ARCHITECTURAL REVIEW COMMISSION AGENDA REPORT

SUBJECT: REVIEW OF THE PROPOSED DESIGN AND LAYOUT FOR THE PHASED MEDIUM RESIDENTIAL DENSITY (R-2) COMPONENT OF THE AVILA RANCH DEVELOPMENT PROJECT, CONSISTING OF 297 RESIDENTIAL UNITS; THE PROJECT INCLUDES A FENCE HEIGHT EXCEPTION FOR A MAXIMUM 13-FOOT TALL COMBIN

FILE NUMBER: ARCH-0624-2020 **FROM:** Shawna Scott, Senior Planner

Figure 7. Proposed Fence Height Exception

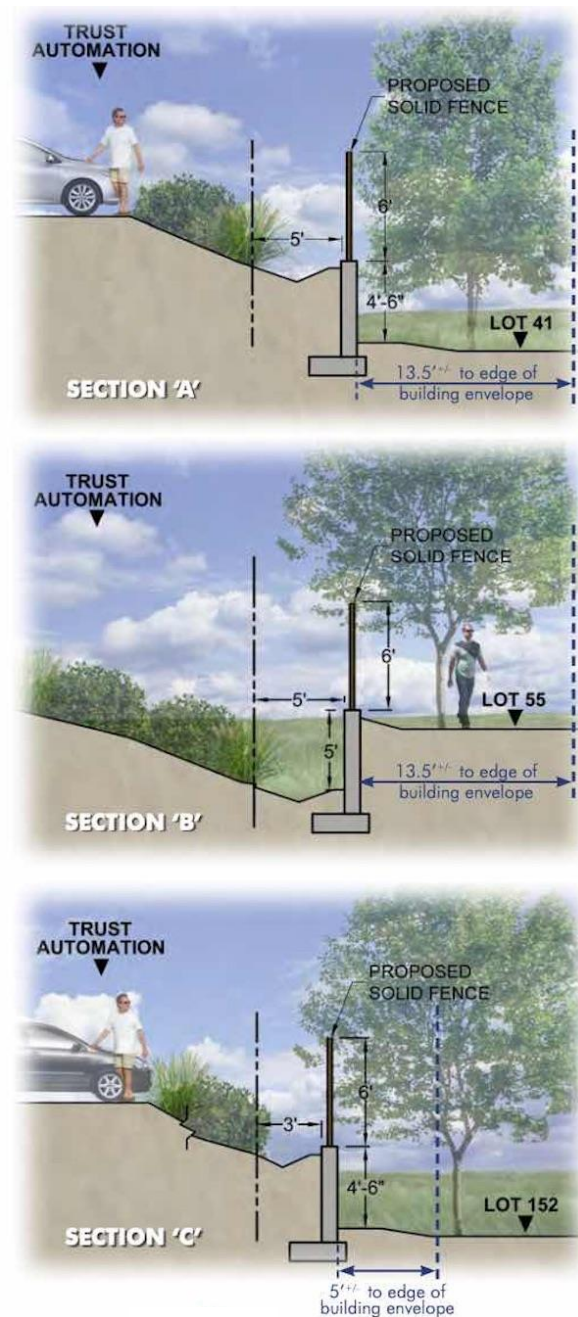
Municipal Code section 17.70.070 allows a maximum wall/fence height of 6 feet along rear and side setbacks or up to 9 feet when combined with a retaining wall. Exceptions to these requirements can be granted for circumstances relating to topography and privacy. A fence height exception is requested along the north and west tract boundaries adjacent to an industrial property (APN 053-259-003) to allow for a 6-foot high solid fence atop a previously approved retaining wall. The requested maximum total combined wall/fence height is proposed at 13 feet.

This exception is requested in response to the site topography and to provide privacy for proposed residential uses from the adjacent active industrial development, notably the parking areas near the property line. The majority of the retaining wall would face the residential development. The proposed fences would be located in the rear and side yards of the residential development and would not be visible along public roads.

See Figure 7 for the proposed fencing concept, which shows some of the detail from Sheet E1.0, included as Attachment 1. The site retaining walls were approved and permitted as part of Tract 3089 Phase 1 Improvements (FMAP-1563- 2018) and are included for graphic reference only to depict the total wall/fence height. The retaining wall varies in height from 2 to 7 feet. Although the combined height of the retaining wall and fence could be as high as 13 feet, because of topographic variation, in other areas it would be under 9 feet. Due to the tract drainage improvements, topography, and location of the approved walls, it is infeasible to offset the fence from the retaining wall.

| Highlighted Sections | Discussion Items |
|--|---|
| <i>ARDP Standard 12.1: Fencing</i> | The intent of this standard is to ensure that fencing design does not block views of open spaces or Tank Farm Creek. The proposed exception to the fence height would apply to areas between residences and industrial areas, not areas associated with open space or the creek. |
